UNITED STATES PATENT AND TRADEMARK OFFICE

APPLICATION NO.	FILING DATE	FIRST NAMED INVENTOR	ATTORNEY DOCKET NO.	CONFIRMATION NO.
10/720,392	11/25/2003	Il Rog Heo	K-0569	4273
34610	7590	09/21/2006	EXAMINER	
FLESHNER & KIM, LLP P.O. BOX 221200 CHANTILLY, VA 20153			KURTZ, BENJAMIN M	
			ART UNIT	PAPER NUMBER
			1723

Office Action Summary

DETAILED ACTION

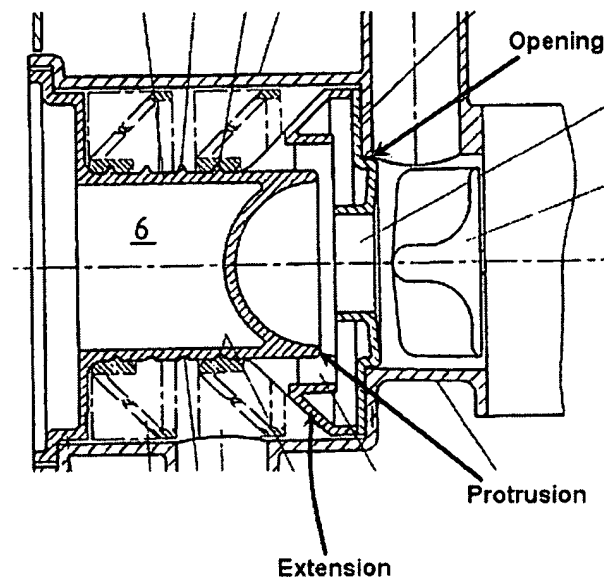
5. Claims 1, 4, 6, 9, 22 and 24-28 are rejected under 35 U.S.C. 102(b) as being anticipated by Beier et al. DE 39 22 629 A1. Regarding claims 1 and 4, Beier teaches a filter for a washing machine comprising: a cap (20) fitted to a filter case having an opening via which water passes, a shaft (11) extending from a bottom of the cap, and a funnel shaped extension extending from an end of the shaft, the extension disposed to confront the opening to the filter particles included in the water, the extension having a protrusion protruding from a side of the extension opposite to the cap wherein the protrusion extends away from the cap and has a diameter that is smaller than a largest diameter portion of the extension (fig. 1 and figure on next page).

Regarding claims 6 and 9, Beier teaches a filter assembly for a washing machine comprising: a filter case (1) having an inlet (4) and an outlet (5) on a circumference, and an opening inside and a filter loaded in the filter case the filter comprising: a cap (20) fitted to the filter case, a shaft (11) extending from a bottom of the cap, and a funnel shaped solid walled extension extending from an end of the shaft, the extension disposed to confront the opening to the filter particles included in the water, the extension having a protrusion protruding from a side of the extension opposite to the cap (fig. 1 and figure above).

Regarding claim 22, Beier teaches a filter for a washing machine comprising: a filter case (1) having a filter chamber with an opening (9), a filter element mounted in the filter chamber, the filter element comprises: a cap (20), a shaft (11), and an extension formed on an end of the shaft opposite the cap, the extension comprises a generally conical shaped solid surface having a diameter that increases in a direction extending

away from the cap, and wherein the largest diameter portion of the extension is positioned immediately adjacent the opening (9) (see figure above).

Regarding claims 24-28, a largest diameter portion of the extension has a diameter that is greater than a diameter of the opening in the case; the filter element further comprises a protrusion formed on a side of the extension opposite the cap and wherein the protrusion extends from the extension in a direction opposite the cap; the protrusion has a circular profile with a diameter that is smaller than the largest diameter portion of the extension; the protrusion is surrounded by the largest diameter portion of the extension; and the largest diameter portion of the extension has a diameter that is larger than a diameter of the opening in the case and wherein a diameter of the protrusion is smaller than the diameter of the opening (see figure above).
